BLDG SECTIONS

16/12/2022

SECTION F-F'

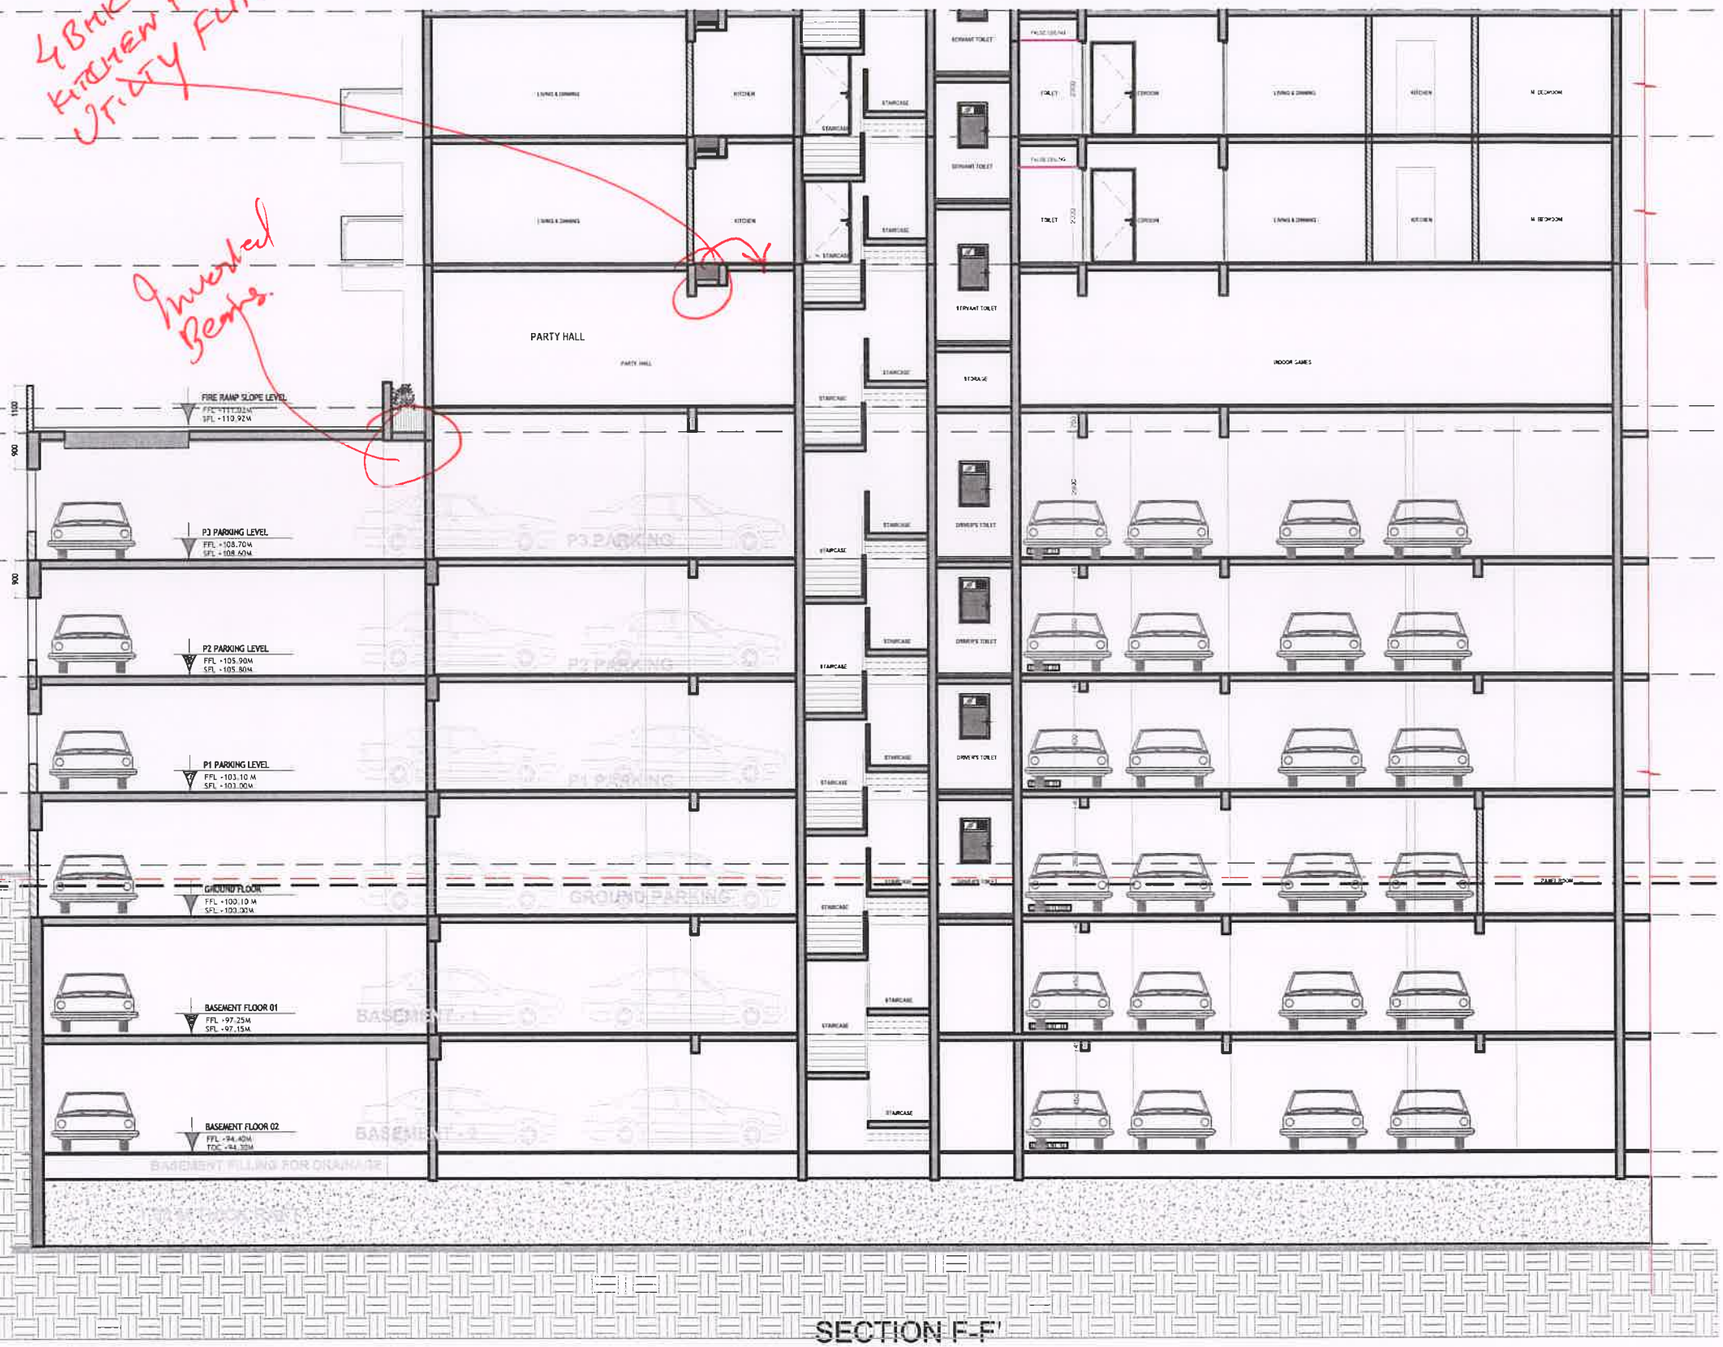
4 BHK KITCHEN & UTILITY FLIPPED.

Inverted Beams.

SECTION GG'

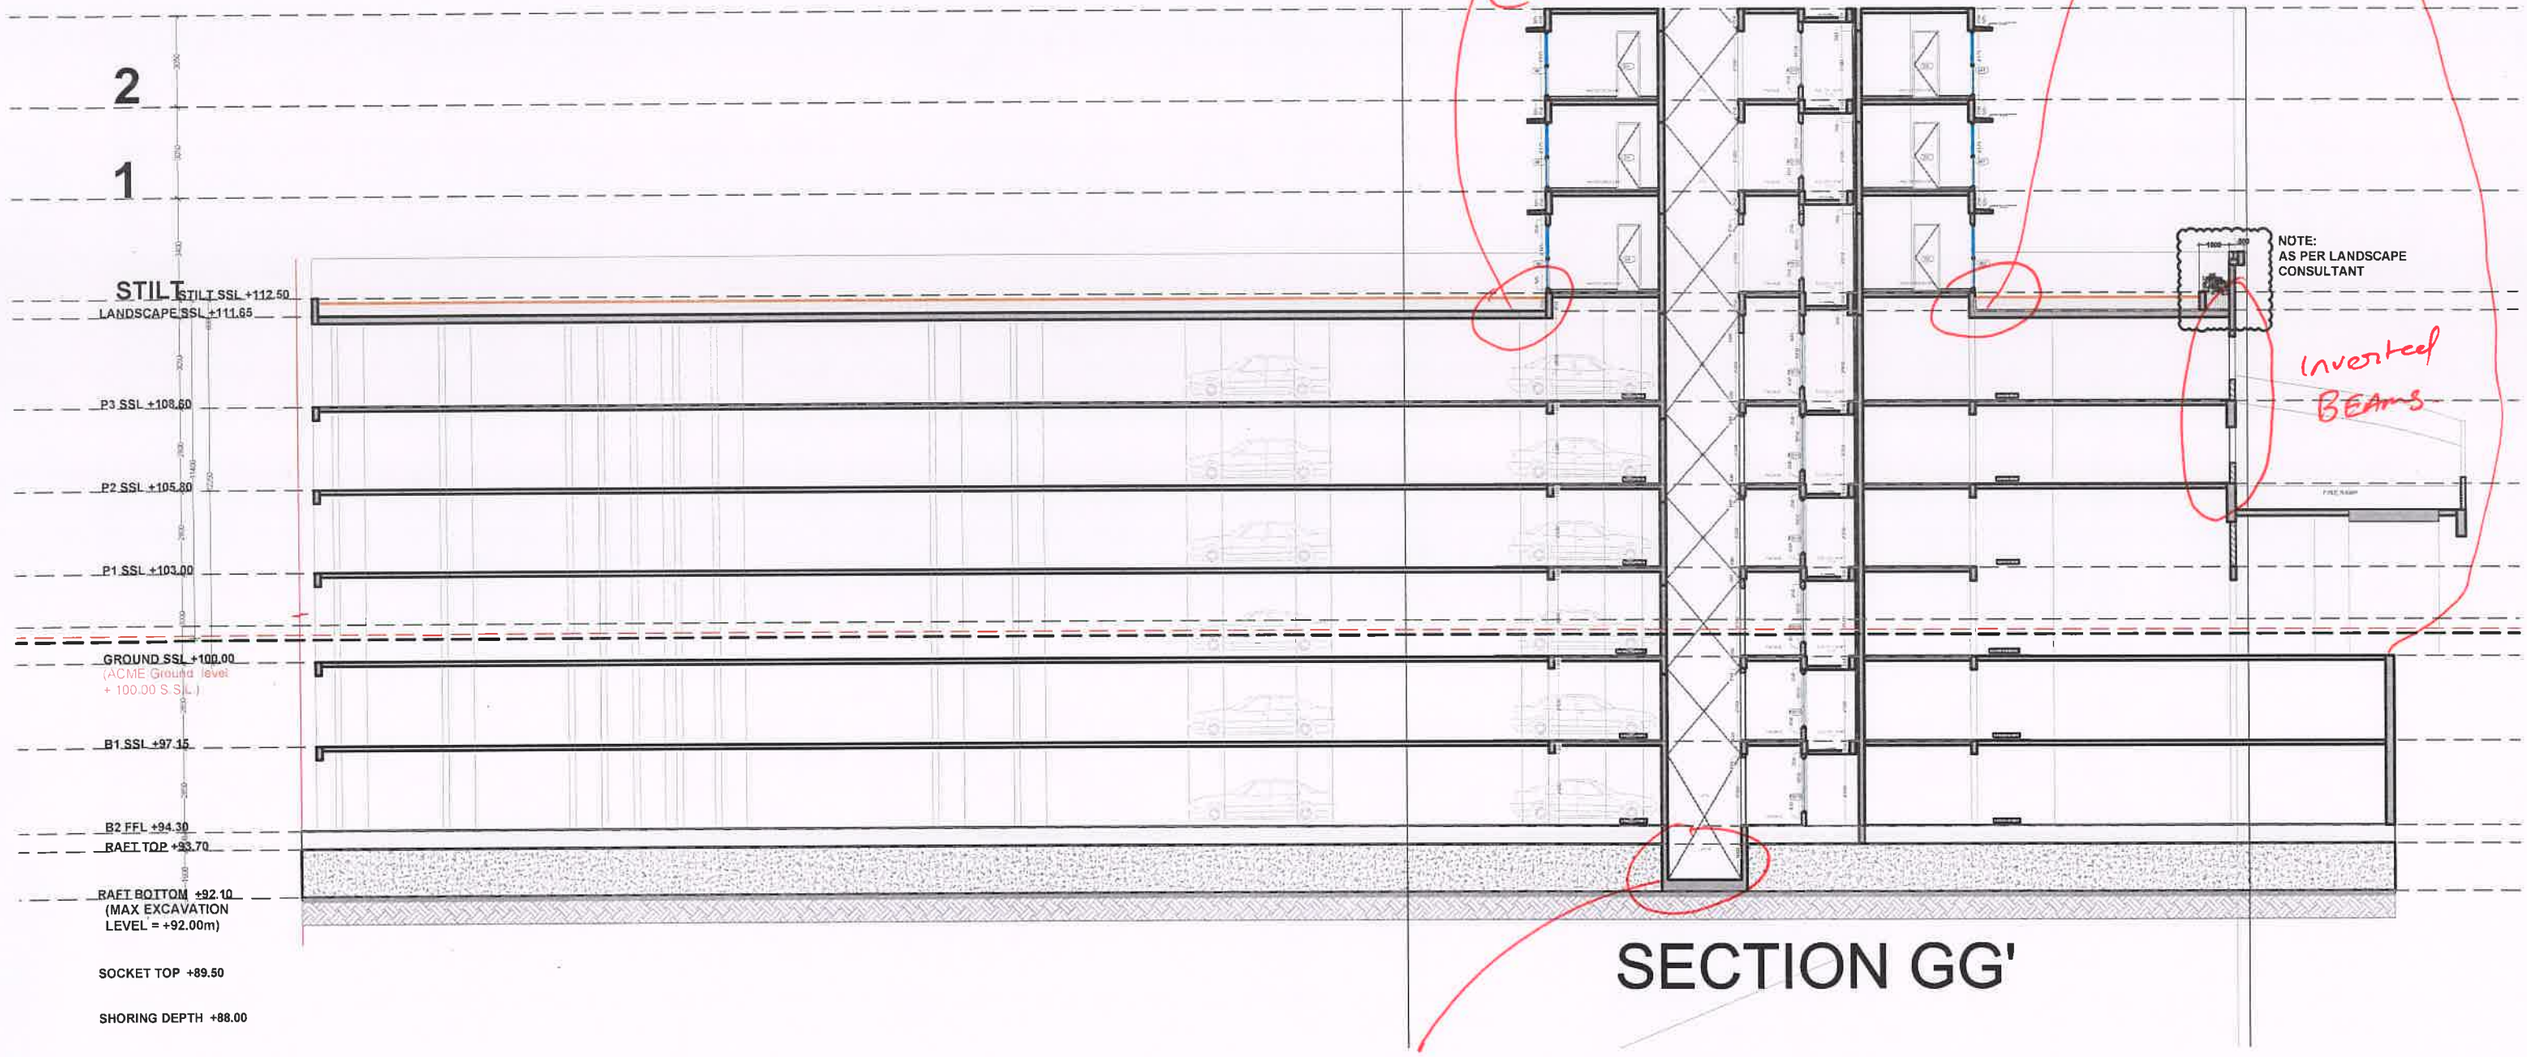
Service
No Slab

As Discussed

Inverted Beams.

SHOW RAINWATER TANK SECTION.
